TOWN OF NAGS HEAD PLANNING BOARD
NAGS HEAD MUNICIPAL COMPLEX – BOARD ROOM

TUESDAY, JANUARY 20, 2026; 9:00 AM

Special Use Permit/Site Plan Review submitted by Albemarle & Associates, Ltd on behalf of Coastal Bluewater Capital, LLC and TW's Bait and Tackle for construction of two buildings to accommodate retail, art gallery, and associated accessory storage spaces. The property is zoned C-2, General Commercial and is located 2230 S. Croatan Highway, Nags Head.

Project: **TW's Building A**

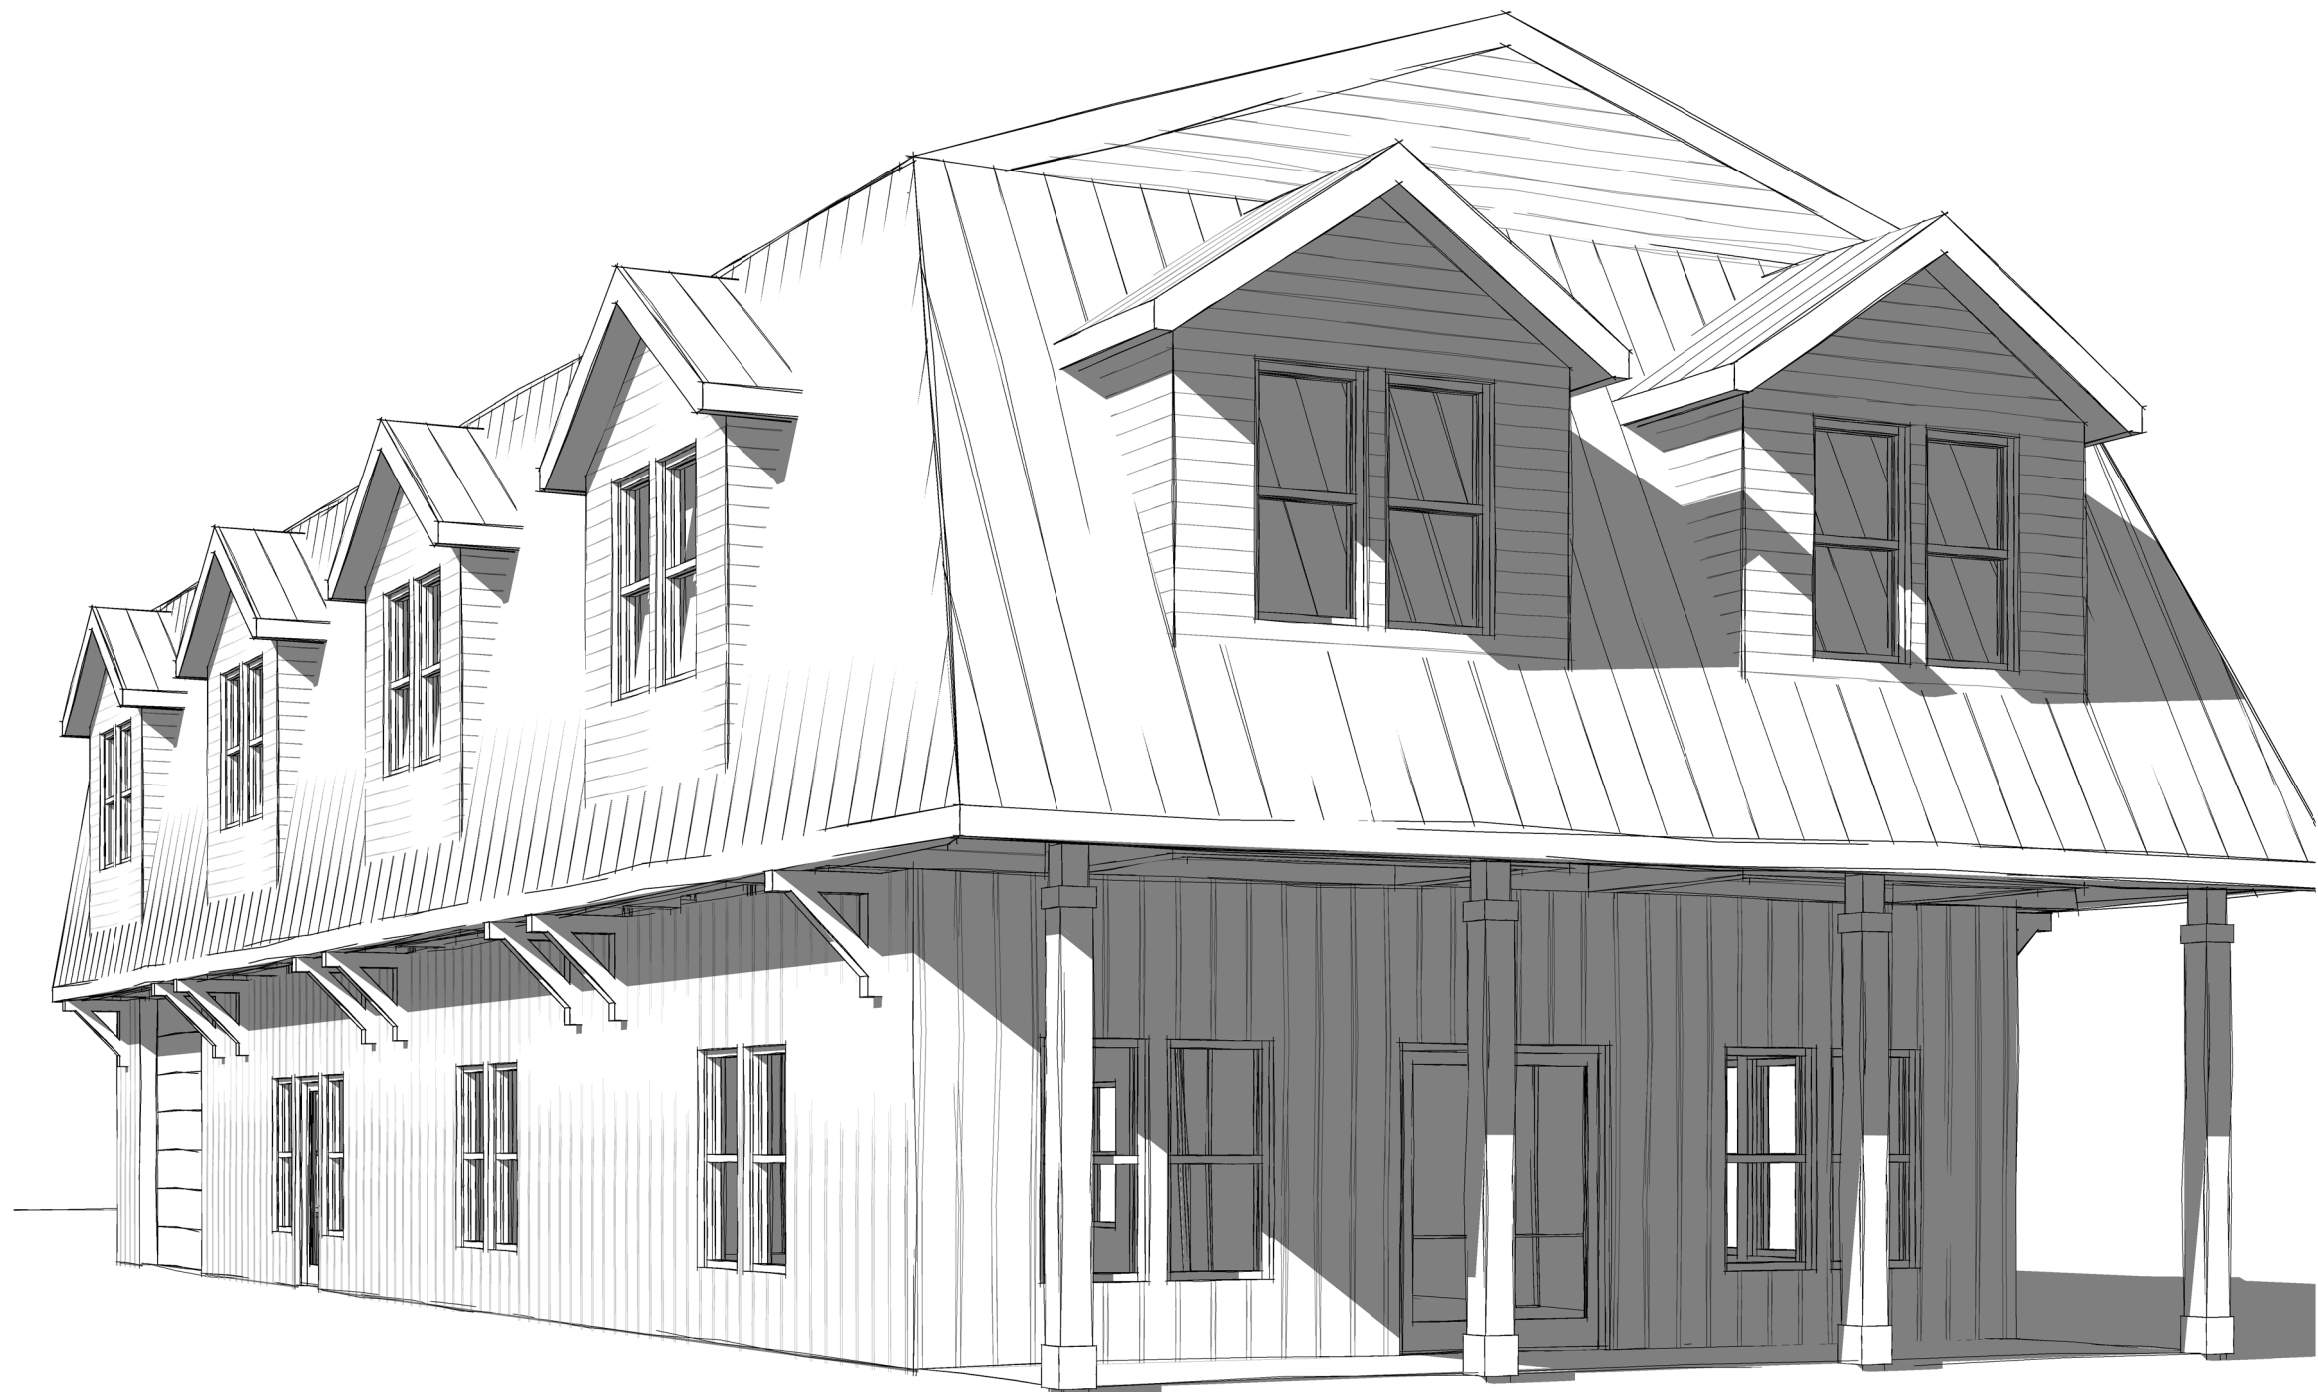
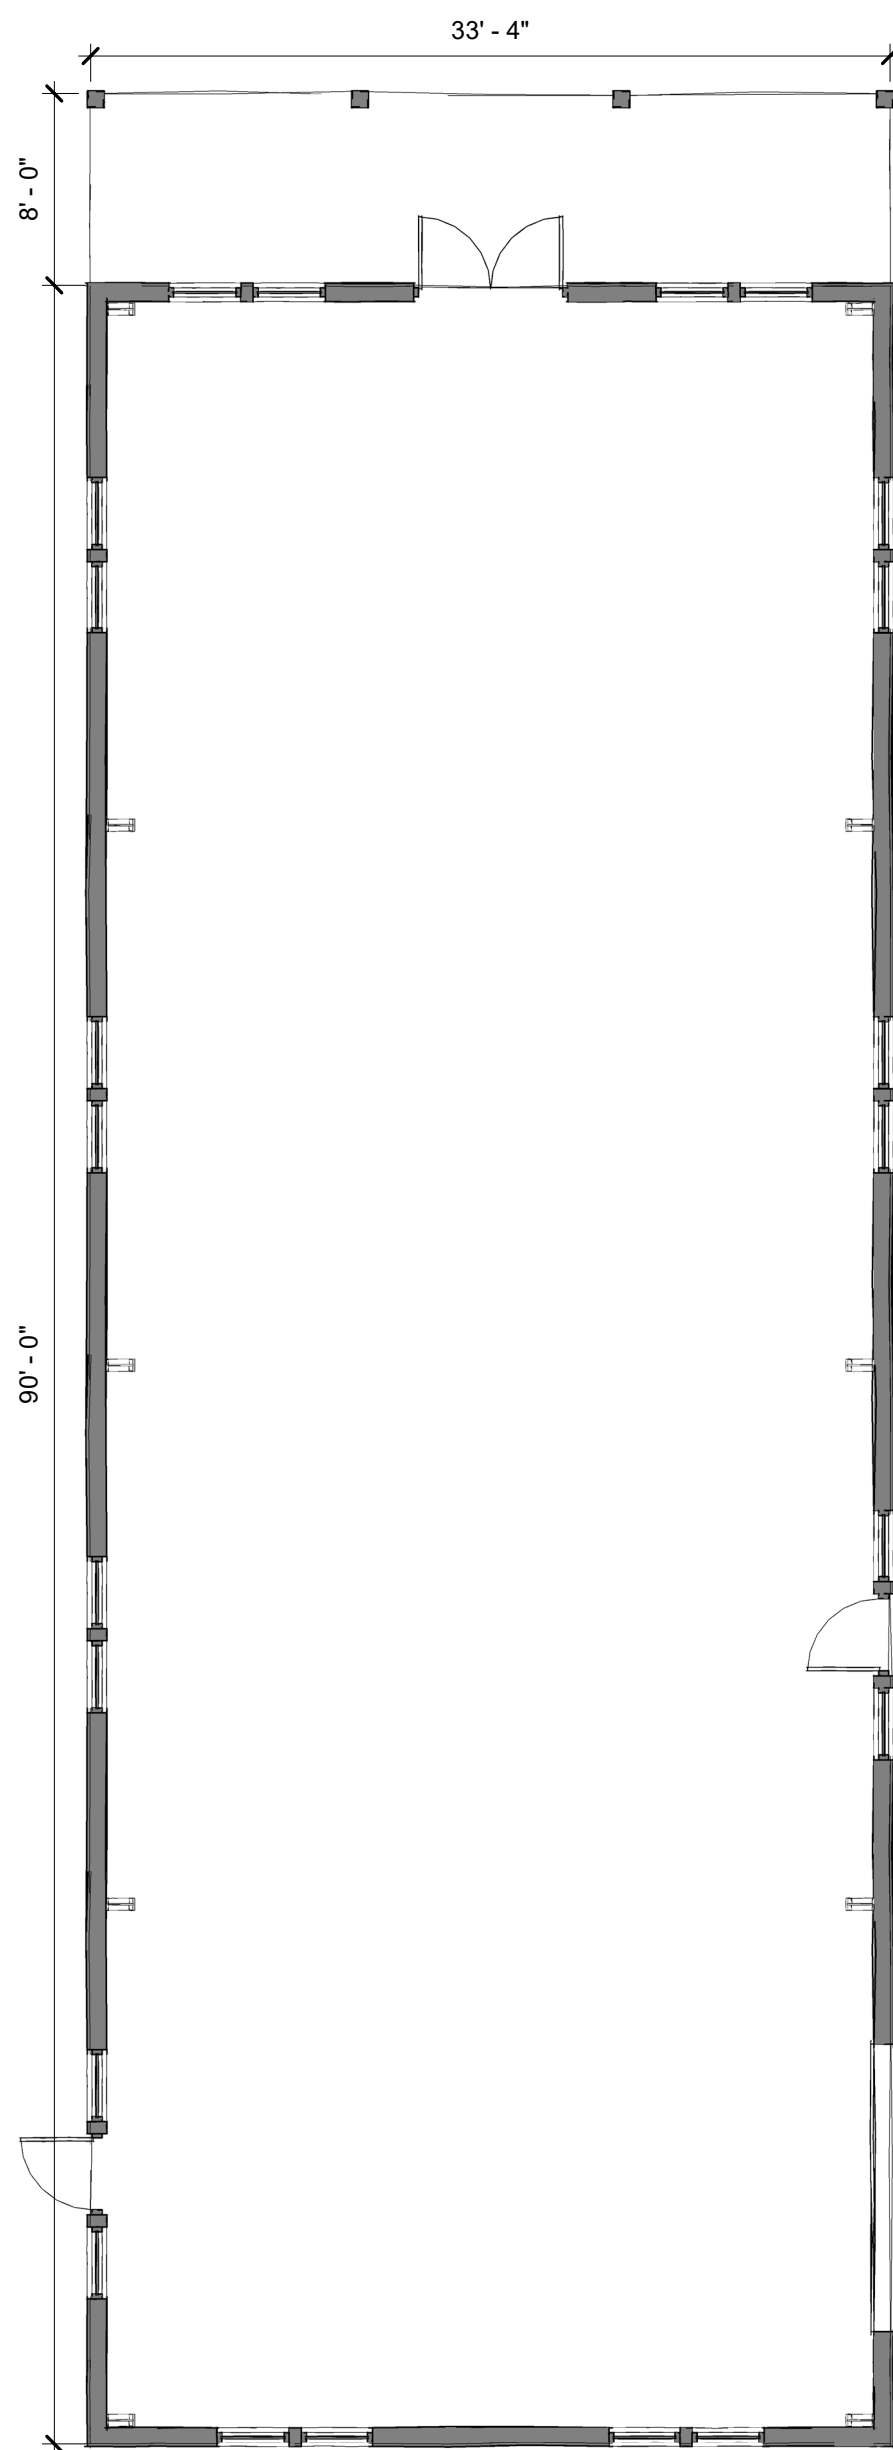
Staff Comment: For this group development project, the applicant proposes a 35-foot-tall, single-story pre-engineered metal building. As proposed, the building utilizes a rigid metal frame construction system rather than conventional wood-frame construction. Unlike wood-frame buildings, pre-engineered metal buildings do not incorporate a continuous wall top plate. In the context of the Town's commercial design standards, the term *top plate* is used as a proportional control that correlates to perceived building mass, wall height, and human scale. Because the proposed building does not contain a true top plate

The building is 50 feet wide and the vertical wall is 26 feet tall. With a height limit of 35 feet, the maximum pitch that can be achieved of the main roof is 4 in 12. The applicant has used a gambrel roof to conceal the upper story of the building and give the appearance that it is incorporated into the roof. The gambrel roof is combined with a series of faux dormers. As the main roof extends beyond the wall, it projects downward to a point where it stops at the line of the porch overhang. Since the lower portion of the roof sits on the outside of the wall and does not actually incorporate the upper story, it increases the mass of the upper portion of the building. The intent of the ordinance is to incorporate the upper story or portion of the building into the roof, thereby reducing the mass. A primary goal of the design should be to reduce the mass of the upper portion of the building. While there may be multiple architectural approaches to achieving roof integration and mass reduction, staff have not evaluated or endorsed any alternative configurations. Based on the submitted plans, staff finds that the proposed design does not meet the intent of the Commercial Design Standards related to building mass and roof integration.

The applicant has proposed a horizontal break at approximately twelve (12) feet above grade in the form of a four-foot-wide projecting upper-level mass along the east, west, and north elevations. This element is located above the ground floor and projects outward from the primary wall plane.

Staff Comment: The proposed buildings are technically single-story structures, as reflected on the submitted elevations, which identify only a first floor with no second floor, mezzanine, or habitable attic space. However, at an overall height of approximately 35 feet, the buildings significantly exceed what is typically associated with one-story construction. The applicant has attempted to address this scale by proposing projected wall-mounted elements identified as “roof bumps” and by creating the appearance of multiple stories through façade articulation. The applicant’s design narrative further characterizes the buildings as “greater than one story,” despite the plans demonstrating otherwise.

Staff Comment: The proposed design includes small, applied elements on a projected wall plane that are intended to visually break up the building; however, these features do not create any actual variation in the roof. As designed, the roof remains a continuous plane exceeding forty (40) horizontal feet without a roof variation. Staff does not believe this design meets the intent of this standard.

Staff Comment: While walls facing public streets include windows and doors, the size, placement, and overall arrangement of these elements do not sufficiently break down the scale of the building contemplated by this standard. As designed, the façade remains visually large and continuous, and the intent of the standard is not met.

Staff Comment: While the window areas generally reflect a residential scale, the doors and entry openings lack architectural detailing or elements that clearly signal building entrances. As designed, the windows and doors are simple and repetitive, resulting in a monotonous façade that does not reflect the level of articulation or coastal detailing commonly found in local architectural styles.

Staff Comment: Based on the submitted elevations, the primary entry doors are compliant with this standard. However, the larger loading and garage bay doors shown on the elevations do not appear to be consistent with the size limitations contemplated by this provision.

Staff Comment: Pedestrian walkways and sidewalks are shown connecting the buildings and parking areas; however, the primary entrances are not clearly identified through architectural detailing as contemplated by this standard. The proposed overhang does not function as a compliant porch and, at approximately four (4) feet in depth, does not provide the scale or articulation typically associated with a defined building entrance. In addition, the entrances lack recesses, roof form changes, or other architectural elements that would visually distinguish them.

SECTION 10.85.2.2 & 3 - AS THE BUILDING IS GREATER THAN ONE STORY, WE HAVE ADDED ROOF BUMPS TO PROVIDE ELEVATION AND MASSING CHANGES TO GIVE THE BUILDING MORE VARIATION.

SECTION 10.85.2.4 - THE DESIGN INCLUDES SIDING CHANGES, BEAUTY BANKS, TRIM, AND BRACKETS TO ADD TO THE VISUAL APPEAL OF THE BUILDING.

Project: **TW's Buiding B/C**

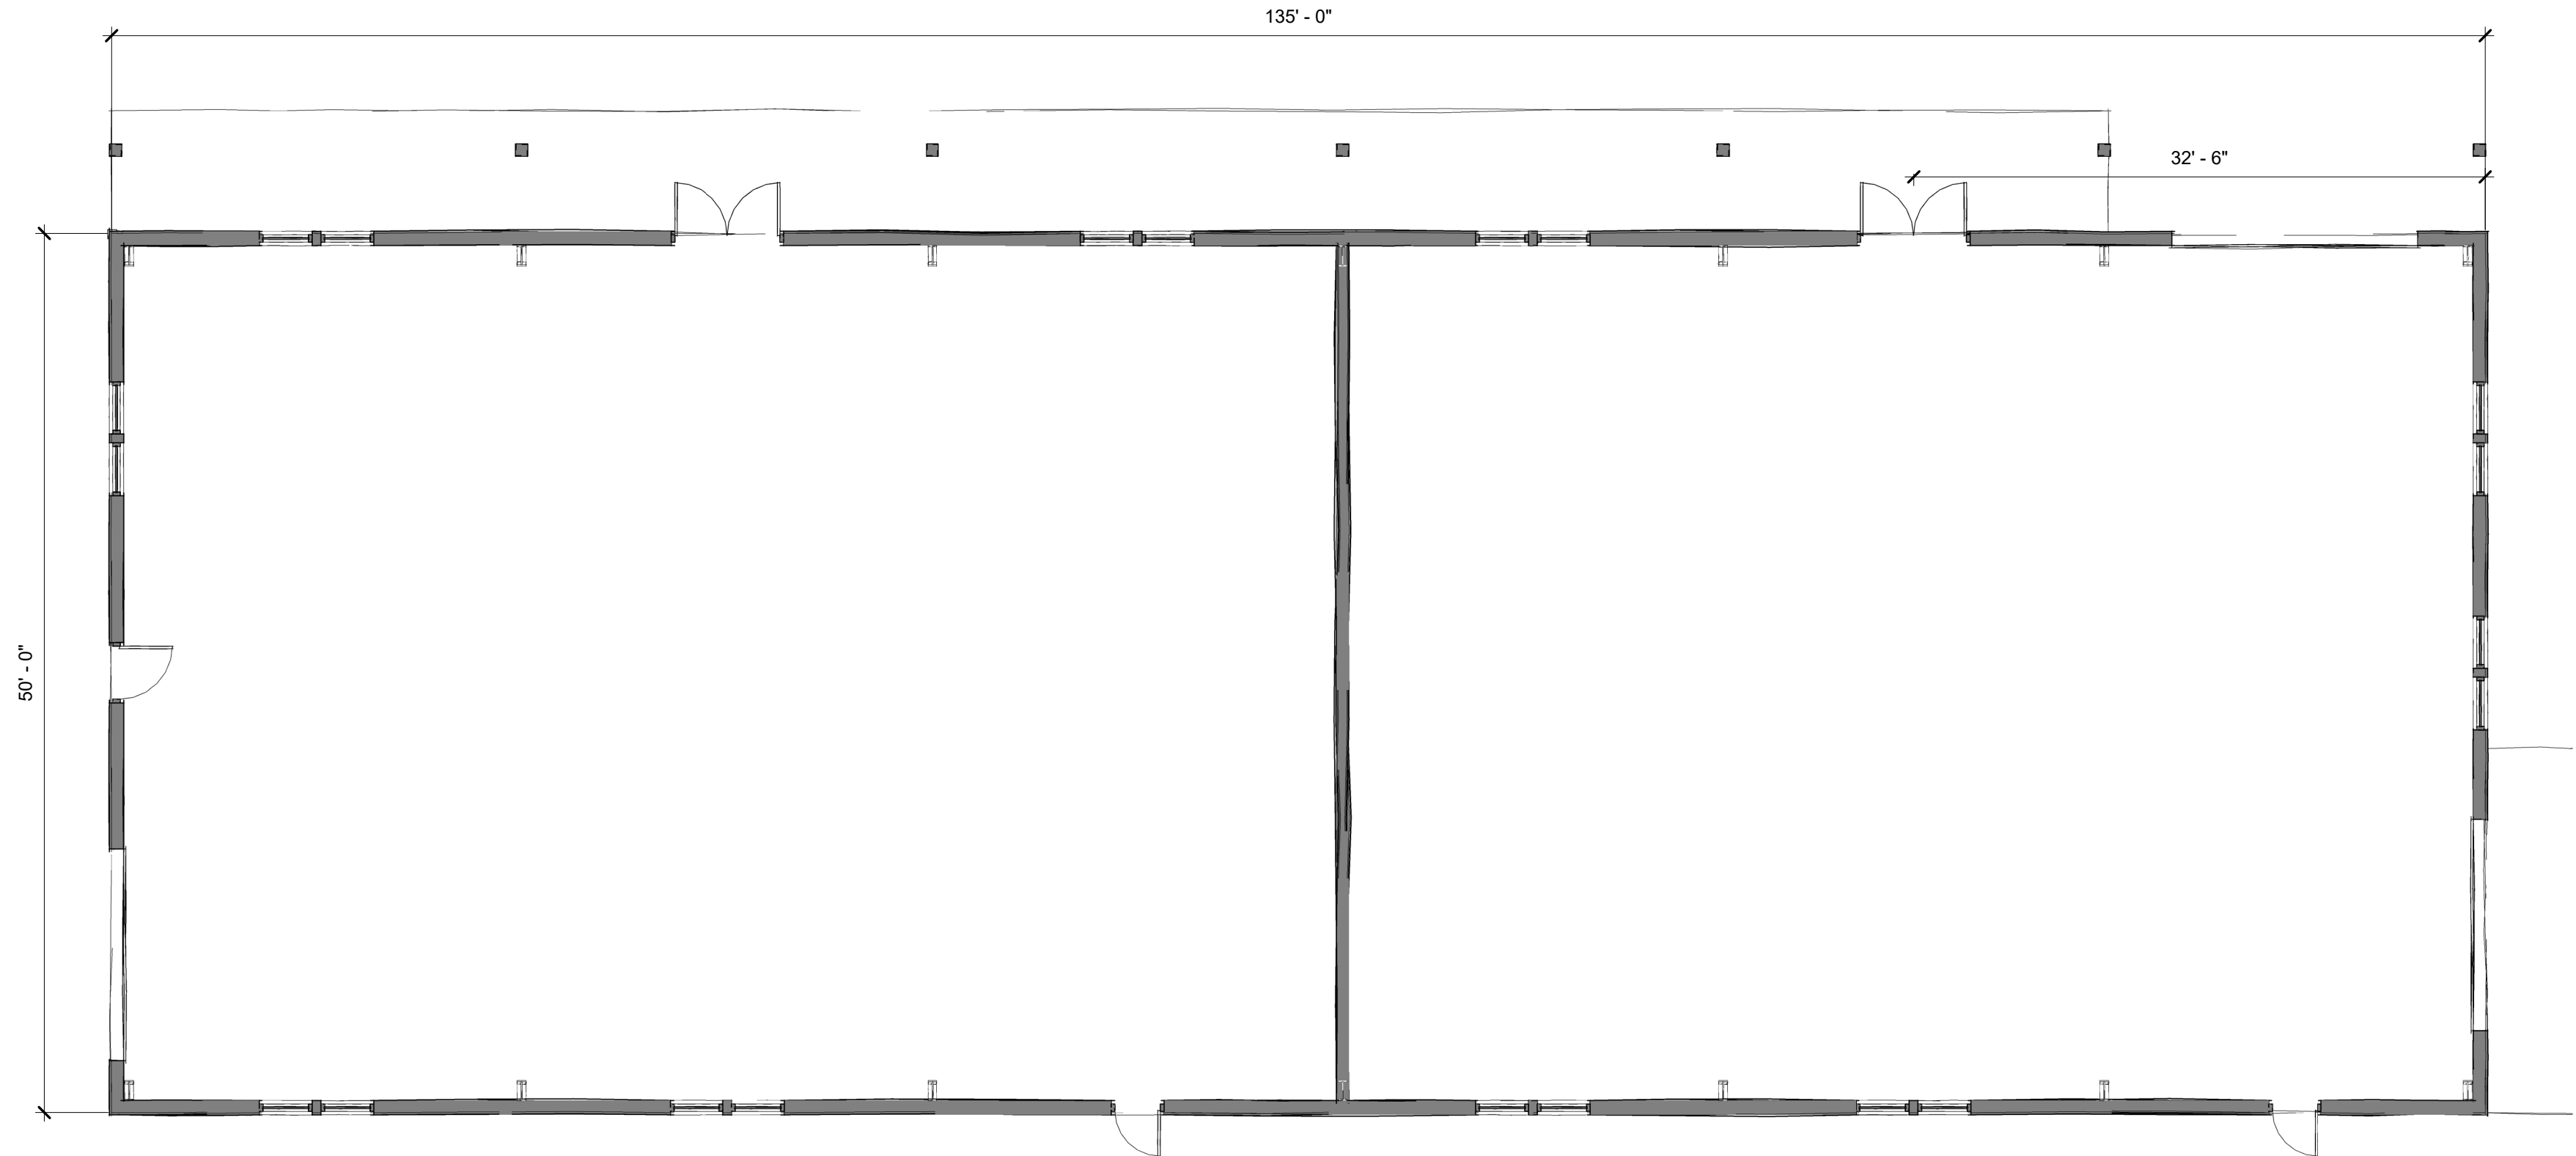
Building B/C is proposed to be 6,750 square feet in habitable area, and Building A is proposed to be 5,000 square feet in habitable area. Building B/C exceeds the 5,000-square-foot threshold established for individual buildings along two-lane roadway sections but does not exceed the maximum allowable size of 10,000 square feet. The applicant did complete a Sketch Plan Review with the Planning Board at its December 16, 2025 meeting. At that time, staff noted that insufficient architectural detail had been provided to fully evaluate compliance with the Town's Commercial Design Standards.

As discussed in previous sections of this report, staff finds that the proposed design does not sufficiently demonstrate that the visual scale of the larger building has been adequately mitigated. Accordingly, while Building B/C does not exceed the maximum allowable size, staff finds that the project has not met the design intent required to support a building exceeding 5,000 square feet along a two-lane roadway.
